**MONTGOMERY COUNTY HISTORIC PRESERVATION COMMISSION**  
**STAFF REPORT**

<b>Address:</b>	7211 MacArthur Blvd., Bethesda	<b>Meeting Date:</b>	9/3/2025
<b>Resource:</b>	Contributing Resource <b>Potomac Overlook Historic District</b>	<b>Report Date:</b>	8/27/2025
<b>Applicant:</b>	Jeong Kim	<b>Public Notice:</b>	8/20/2025
<b>Review:</b>	HAWP	<b>Staff:</b>	Dan Bruechert
<b>Permit No.:</b>	1126423	<b>Tax Credit:</b>	Partial
<b>Proposal:</b>	Fenestration Alterations

The applicant proposes to remove and replace two windows in kind and to alter two existing window openings.

**Figure 3:** Proposed rear elevation, replacement aluminum windows circled.

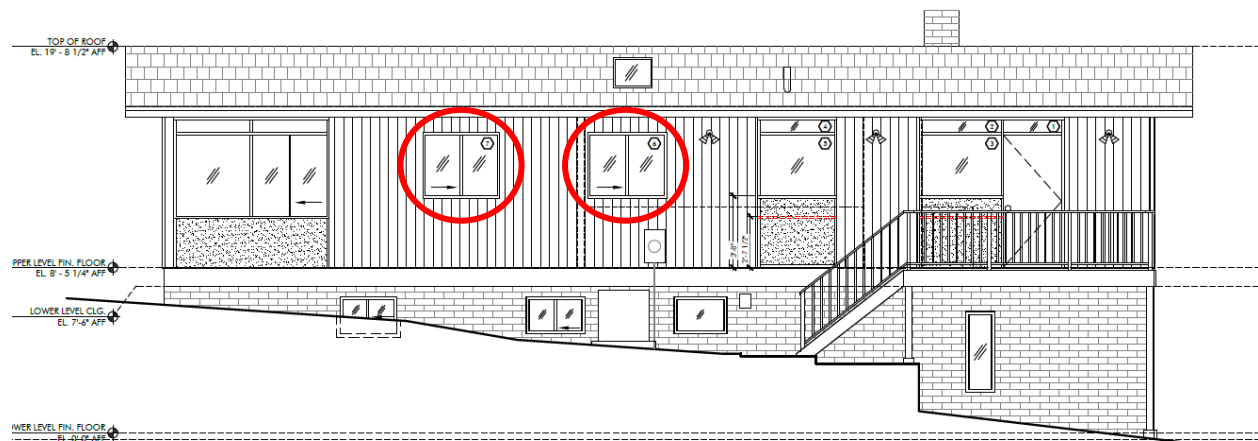
On the north side of the house, the subject property retains its historic windows and doors. The applicant proposes to replace the two aluminum slider windows with new dual-paned aluminum slider windows in wood frames constructed to match the existing (see *Figure 3*, below). The two windows will be installed in a bathroom and in the reconfigured kitchen.

The applicant has identified that these windows are worn and deteriorated, likely due to their exposure to moisture over the last 70+ years. As these windows are aluminum, they cannot be repaired. Staff supports the window removal under *Standard #6*.

The proposed windows will be aluminum slider windows that match the existing windows in dimensions and profiles in new wood frames. The only difference from the historic windows is the new windows will be double paned.

Staff finds the proposed window replacement satisfies the design objectives for windows in the *Design Guidelines*, primarily by installing aluminum sash sliders (*Window Objective #4*) that are in-kind with the historic (*Window Objective #5*). Staff supports the removal and replacement in-kind of the two aluminum sash sliding windows under 24A-8(b)(2), the *Design Guidelines*, and *Standards #2* and *6*. These window replacements are eligible for the county's historic preservation tax credit, as they are replacing deteriorated windows in-kind.

**Figure 4: Proposed window alteration, the dashed red line notes the height of the existing sill.**

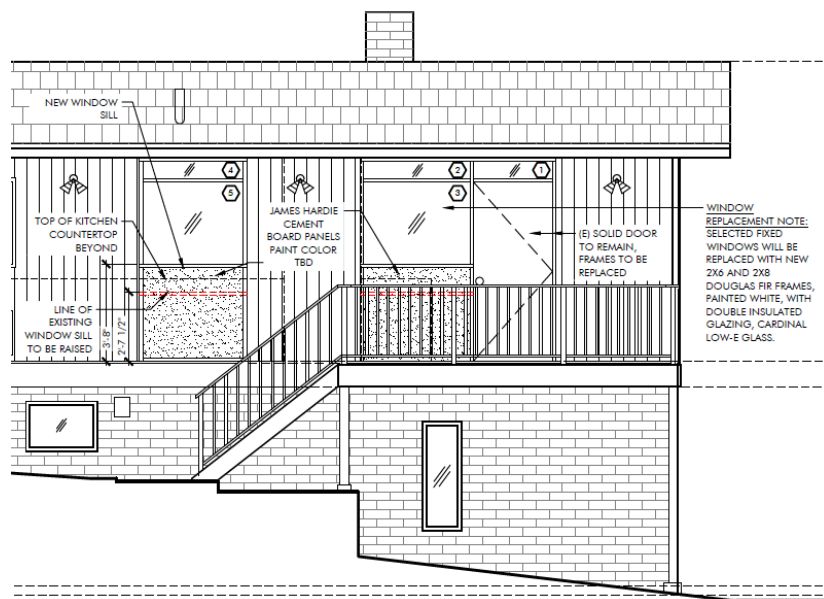
To the right of the proposed replacement windows, the applicant proposes to remove the existing picture windows, reduce the size of the opening, and install new aluminum fixed windows. The change in size of these windows will accommodate a reconfigured kitchen. The applicant worked with Staff on multiple iterations of the proposed design to preserving the existing historic character and materials to the greatest extent possible while allowing for modest changes that would satisfy the homeowners' objectives.

The proposed new windows will be 1' ½" (one foot, one-half inch) shorter than the historic (see *Figure 4*, below). Fiber cement panels, matching the appearance of the existing, but 1' (one foot) taller will be installed below the windows. The narrow fixed transom windows above will be replaced with new aluminum fixed windows in matching dimensions. The revised window size is intended to accommodate the counter and appliance height of the reconfigured kitchen.

Staff notes that the north elevation will maintain the characteristics of the “downhill side” of the building that includes a single-leaf entry, and limited windows. Staff finds that while the applicant proposes to remove the historic windows, the ratio of solids to voids and overall character of the building will be retained. Staff additionally finds that the proposed windows will retain the design and configuration of the existing window (*Window Objective #4*) and the panels below the windows will be replaced with fiber cement panels that match the appearance and texture of the existing (*Siding Objective #8*). Staff finds the proposed replacement transom windows is a replacement in-kind and satisfies the window *Design*

*Objectives #1 and 4.* Staff recommends the HPC approve the window alterations under 24A-8(b)(2) and (d), the *Design Guidelines*, and *Standards #2 and 6*.
